**CHANGE ORDER REQUEST SUMMARY**

PROJECT : Spring Lake Park City Hall Renovation / Expansion

# Proposal Request

PROPOSAL REQUEST NO: 10  
DATE: 7/15/2024  
PROJECT NO: 193806049  
CONTRACT FOR: Building Construction

**A MAIN LEVEL PARTIAL ENLARGED SYSTEMS PLAN**  
 0 2' 4' 8'

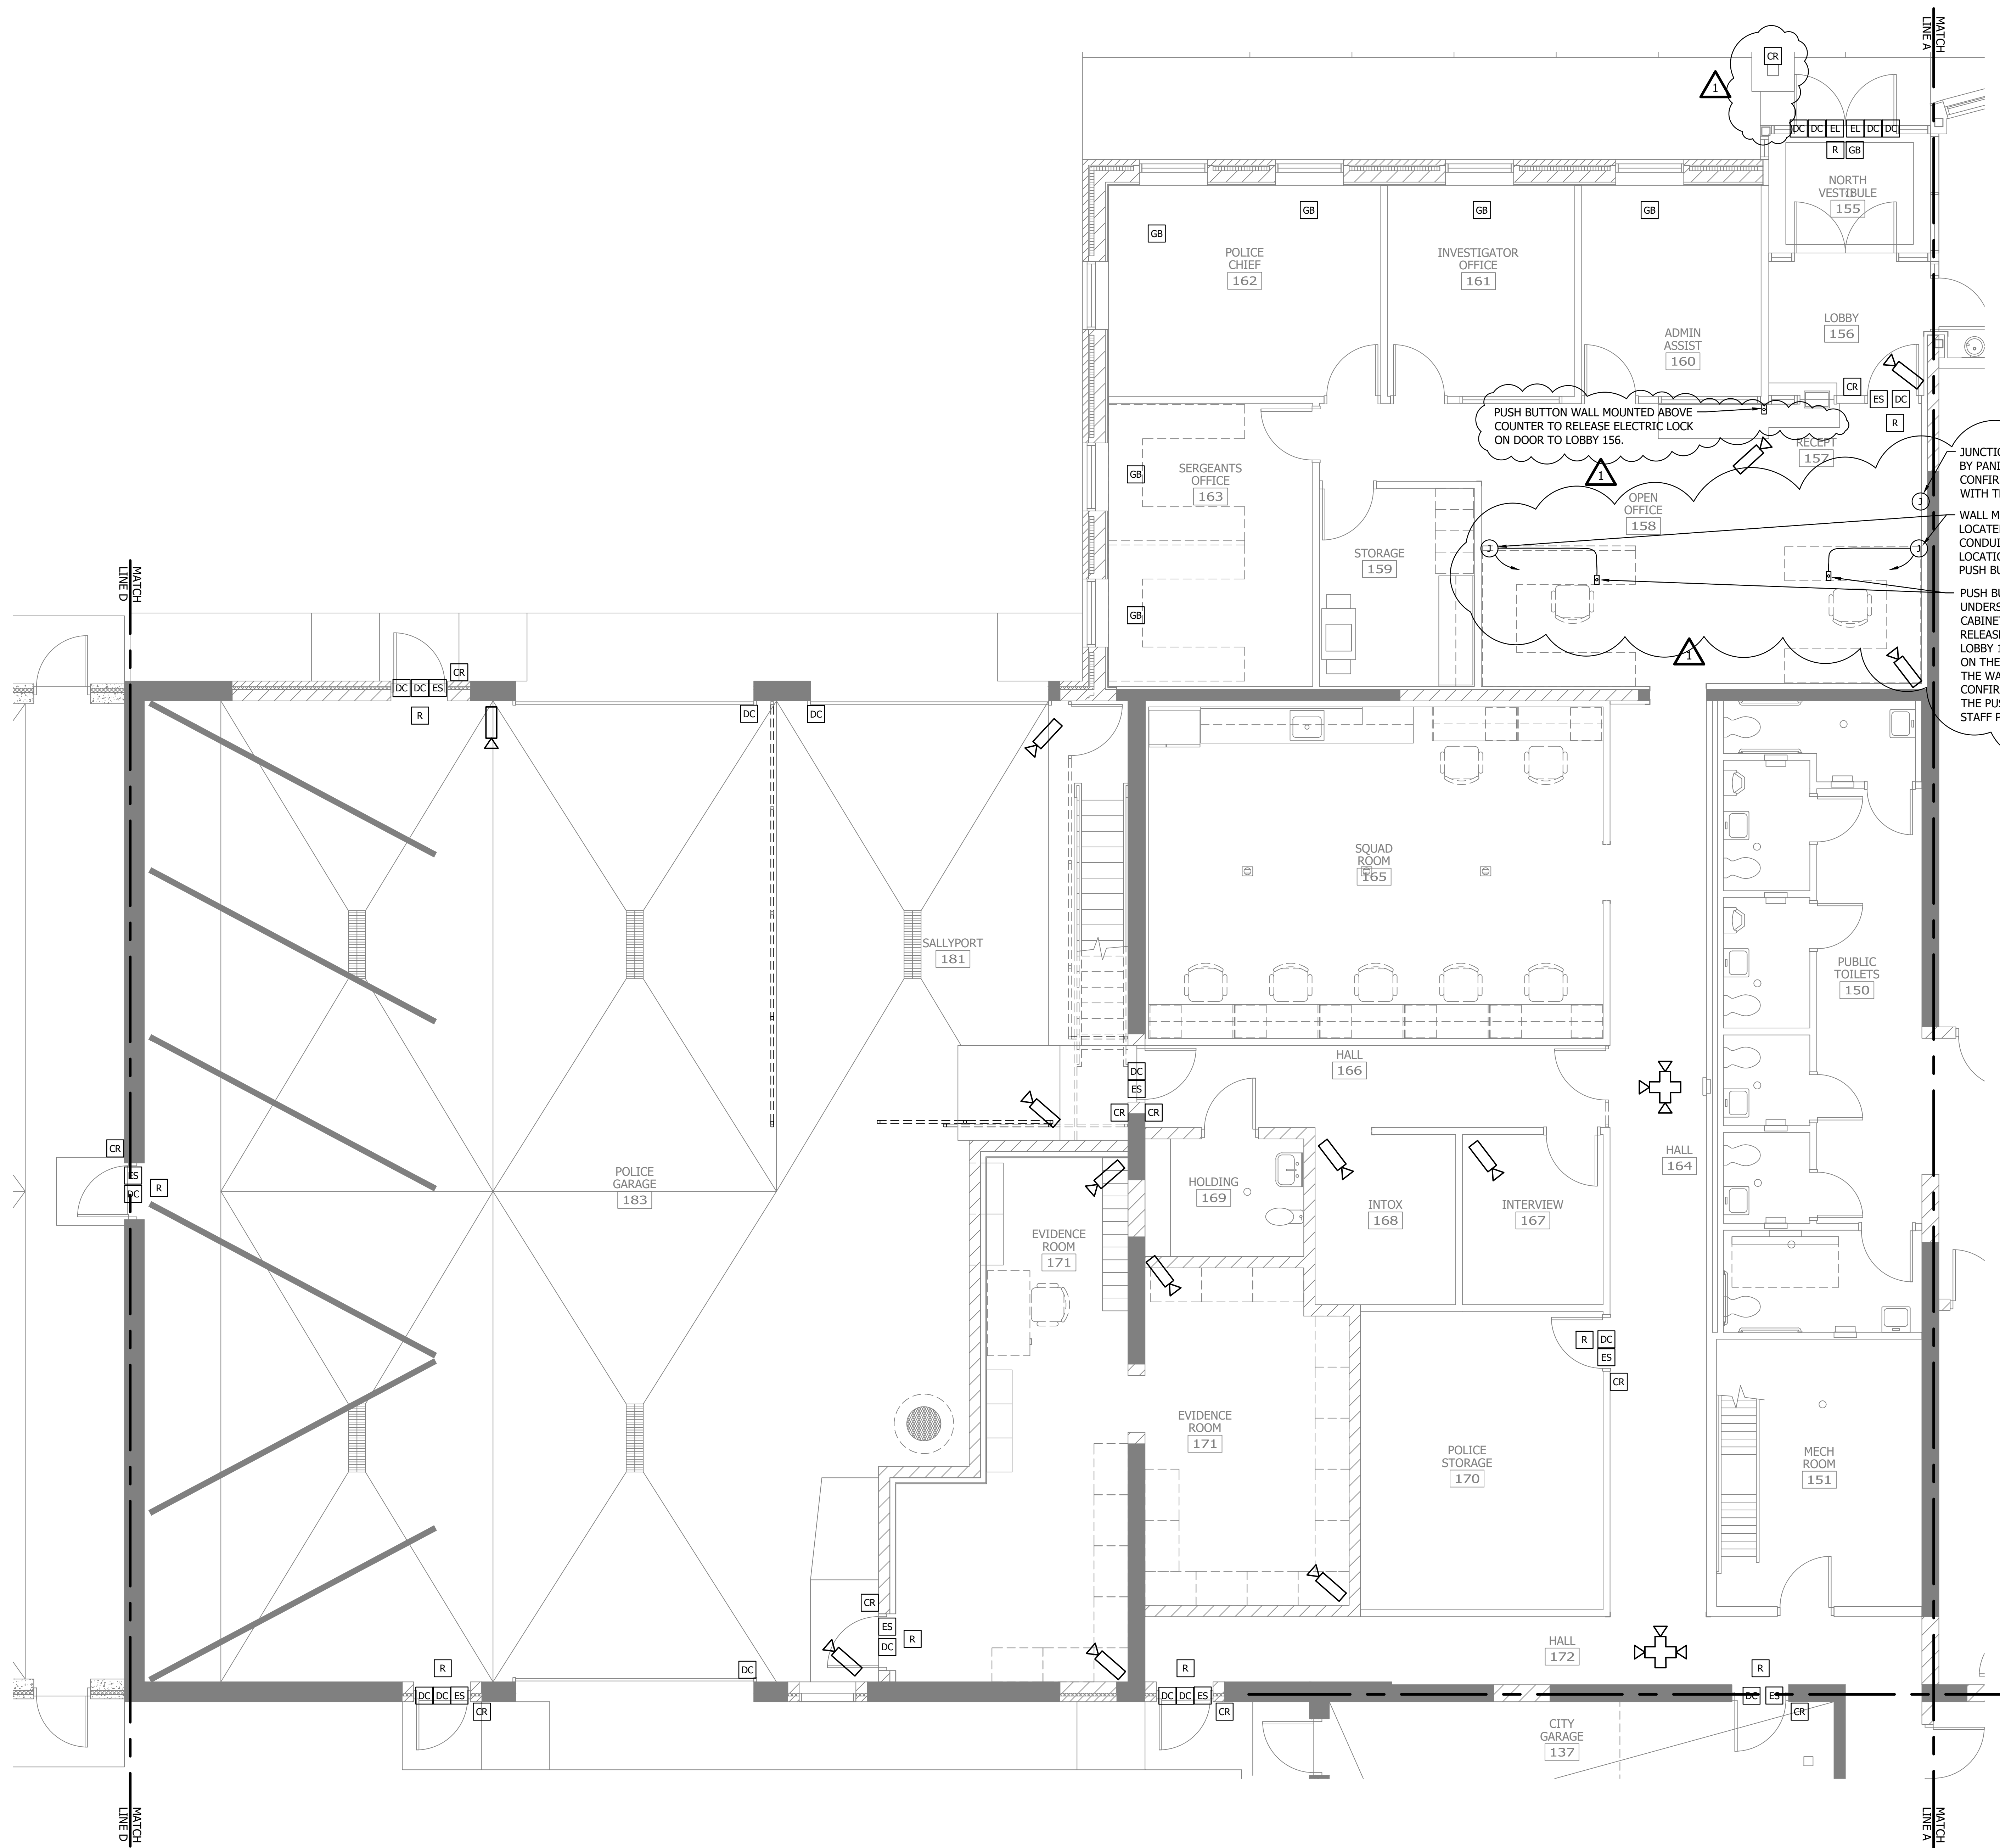
1. Revise plan to show card reader for doors 155-1 mounted on 8" square steel bollard as indicated.
2. Revise plan to add push button at counter and work stations to release electric lockset on door 157-1 as indicated.

1. Revise plan to show wall-mounted audible alarm in Reception 156 connected to the panic buttons in Reception 104 as indicated.
